74 Front seat side trim loose or broken

74 15 22 2042470/1 December 1, 2015.

Model(s)	Year	VIN Range	Vehicle-Specific Equipment
TT	2016	All	Not Applicable

Figure 1. Outer front seat side trim loose.

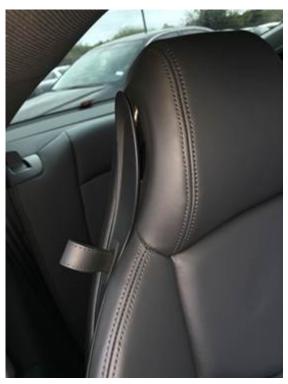
The trim on either side of the front seat backrest is loose or broken (Figure 1, Figure 2, and Figure 3).

The material used in the construction of the trim pieces is of insufficient strength and can break under normal use.

The front seat backrest trim strips have an improved material.

- 1. Replace both side trim pieces of the affected seat only.
- 2. Replace loose or broken trim strips with replacement parts marked with "15S", following the instructions in Elsa at: Body>>Body Interior>>74 Seat Upholstery, Covers>>Front Seat Covers and Cushions>>Backrest Cover and Cushion, Removing and Installing>> Backrest Cover and Cushion, Removing and Installing, Super Sport Seat.
